City of Portland, Maine - Building or Use Permit Application

Past Use: 2 Family Home	Proposed Use: 2 Family Home - Additon of Shed Dormer 17' long	Permit Fee: \$170.00	Cost of Work: \$14,950.00	CEO District: 2
Proposed Project Description: Additon of Shed Dormer 17' long <i>Dormer on #17 side #2nd FL Bath remodel #17</i>		FIRE DEPT: <input type="checkbox"/> Approved <input type="checkbox"/> Denied	INSPECTION: Use Group: <i>R-3</i> Type <i>SB</i> <i>IRC-2003</i>

Proposed Use: 2 Family Home - Additon of Shed Dormer	Proposed Project Description: Additon of Shed Dormer -17' long
--	--

ROOF BEAM DETAIL & SPANS
FOR BARB & RON WARD
15 & 17 WINTER ST - PORTLAND
16 JUNE 2008
PREPARED BY BOB GRAHAM
BOBS COASTAL CONTRACTING LLC

SCALE 1/2" = 1'

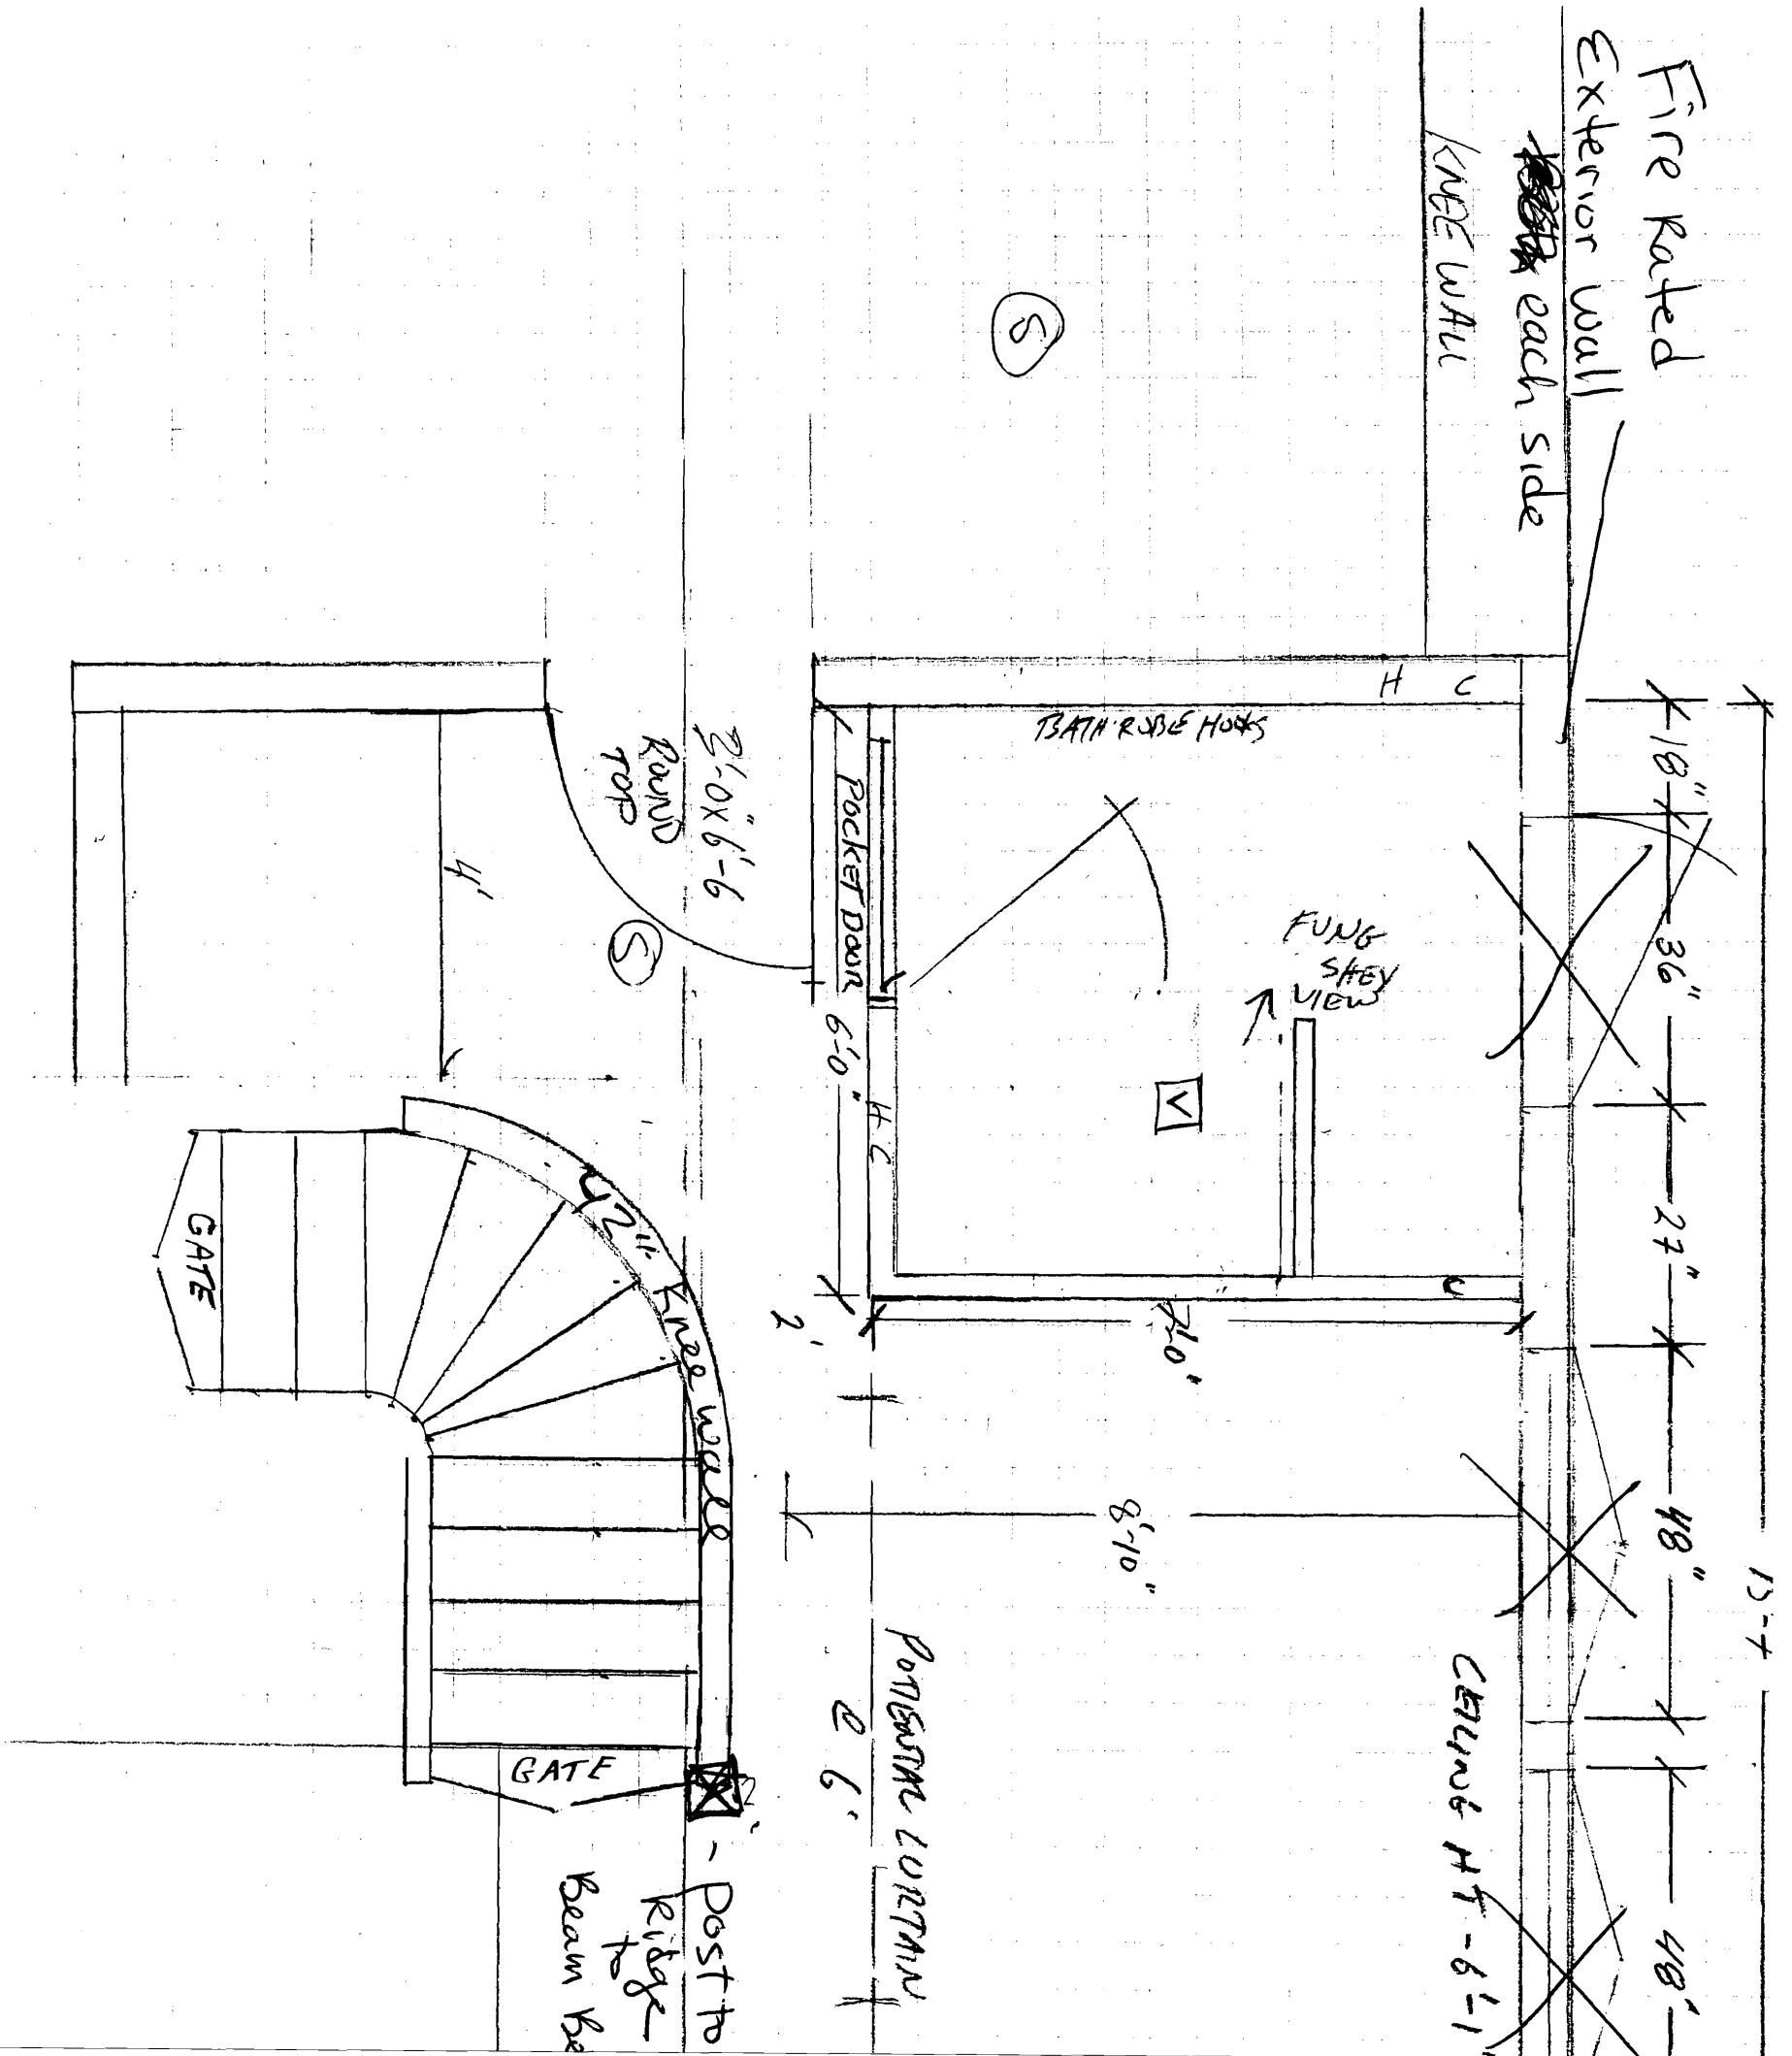
Fire Rated
Exterior wall
~~each~~ each side
KNEE WALL

KNEE WALL - 11/11/11 - ADD 6"

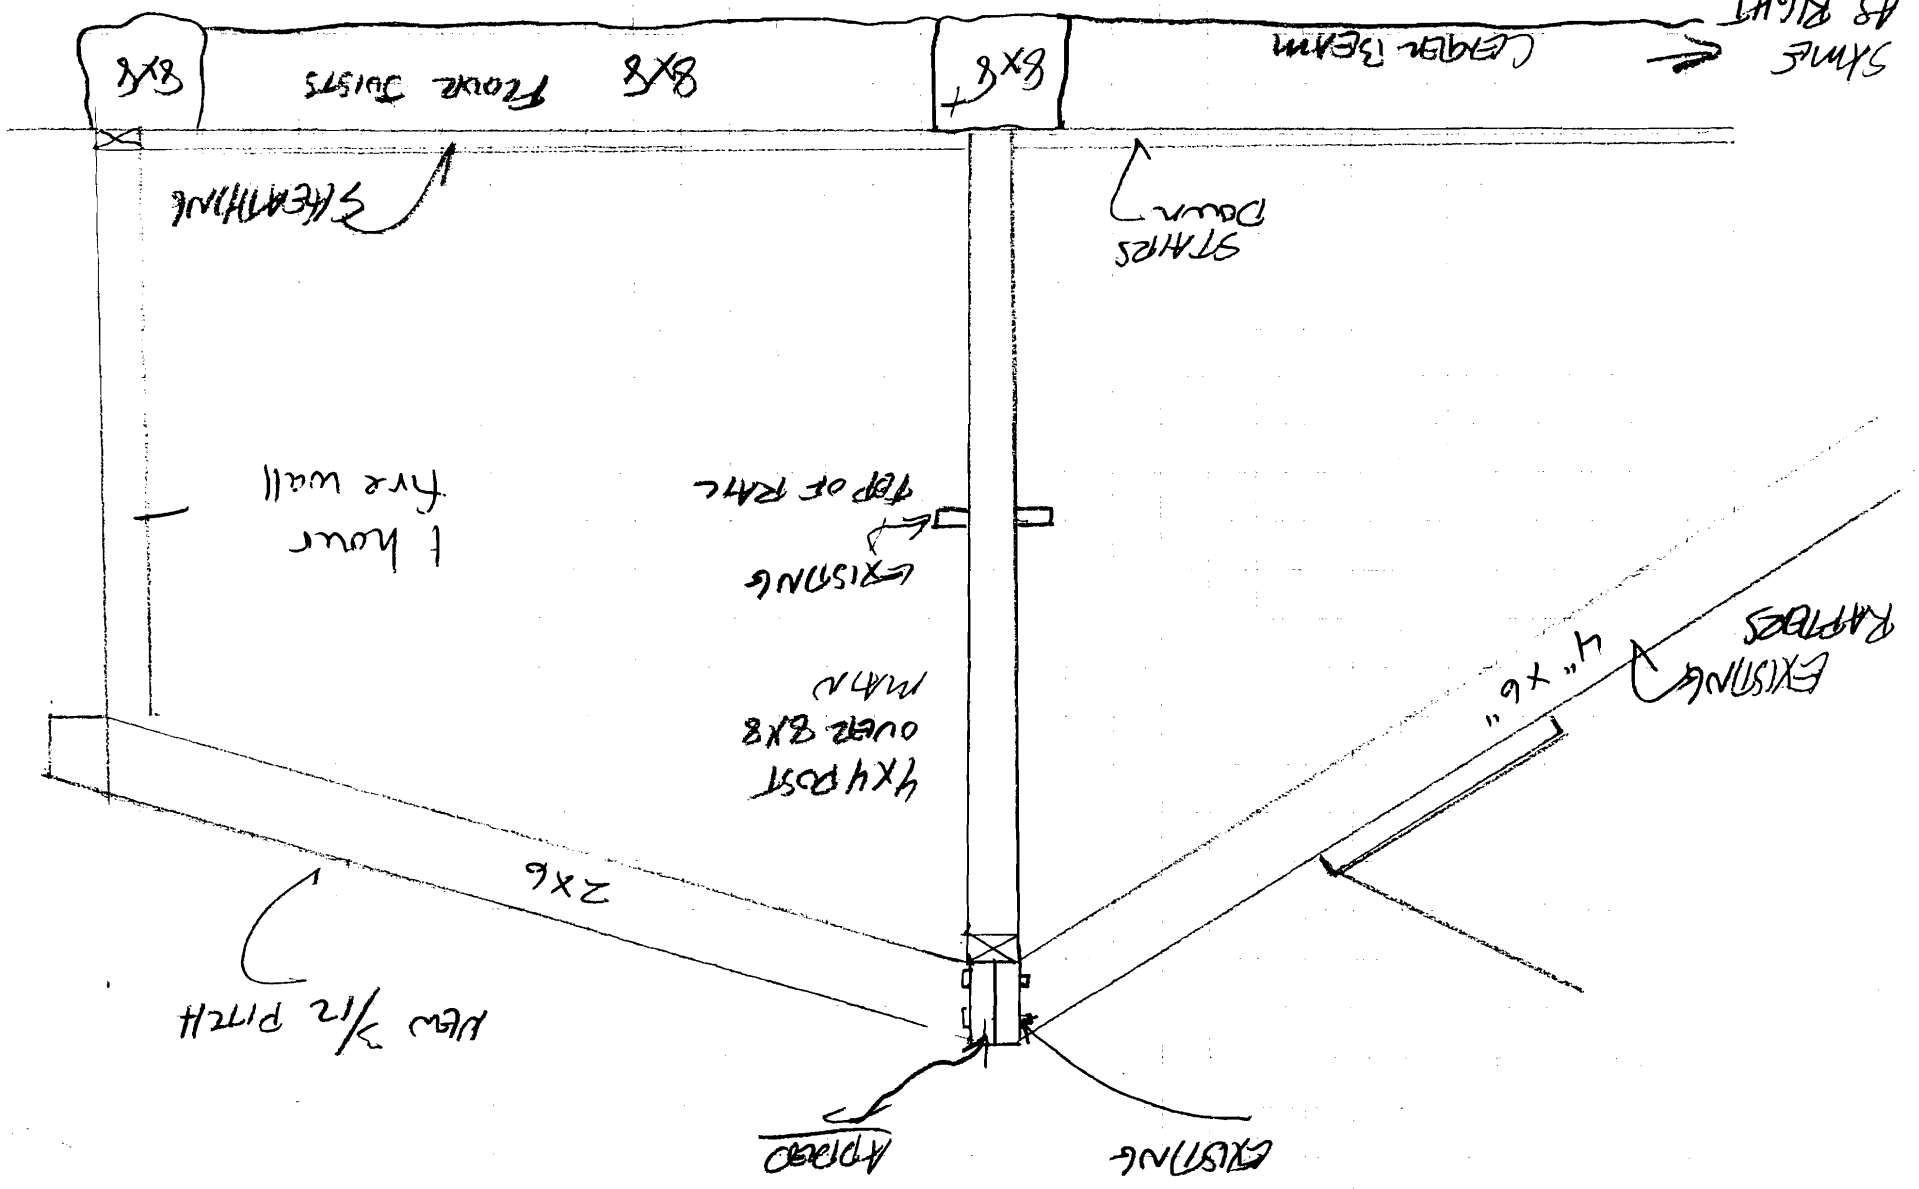
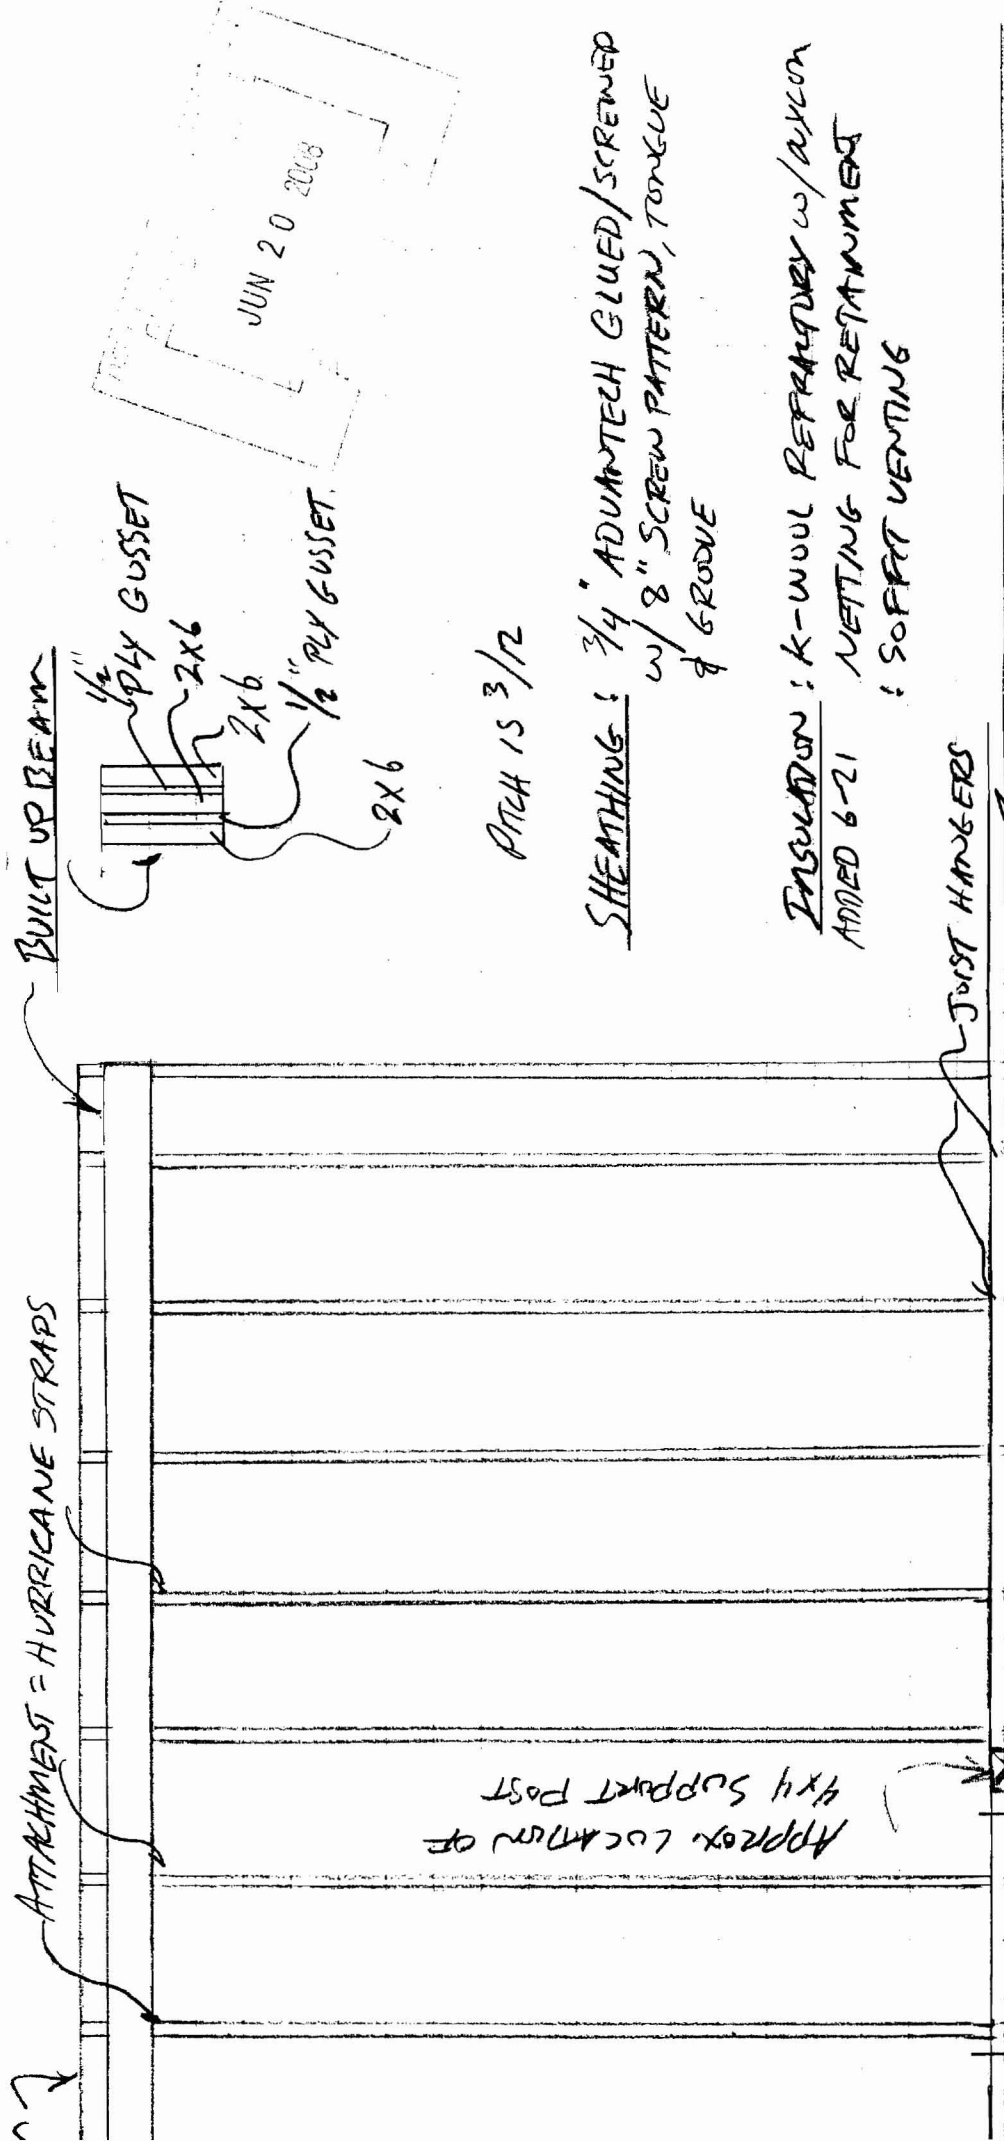
5/16/2008-jmb: Spoke to Bob G. This is an attic space and historic will not allow to bump up the roof to meet headroom code. Other required details, headroom not adequate, need existing stair details, structural beam, fasteners, lumber dimensions, load of existing attic floor. Bob says they are sistering the floor joists to create a 100 psf load....need details. Doesn't look hopeful for approval per code.

Thanks Bob....I will take a look at this, but the drawings will be most helpful. I'm not sure what your experience obtaining building permits is in other states/cities, but here in Portland, we require very detailed plans showing all phases of the work. In this instance some of the code issues may have been realized early in the process if a design professional had been involved.

I AM ENCLOSED A DRAWING OF THE SHED DRAWN & ITS STRUCTURAL DETAILS & WHAT I DID RE: THE RIDGE BEAM.

EXISTING SPAN
IS 8'-8" 7/8"
INSIDE TO INSIDE
OF BEARINGS

TABLE 22 SIZE	SPACING	# 15.X.P.	# 25.X.P.R.
2X6	16.0"	10-7"	10-2"
2X6	19.2"	9-11"	9-4"

ATTACHMENT = HURRICANE STRAPS

BUILT UP BEAM

SHEATHING: 3/4" ADVANTECH GLUED/SCREWED
w/ 8" SCREW PATTERN, TONGUE
& GROOVE

INSULATION: K-WOOL REFRACTORY w/ AXICON
ADDED 6-21 NETTING FOR RETAINMENT
: SOFFIT VENTING
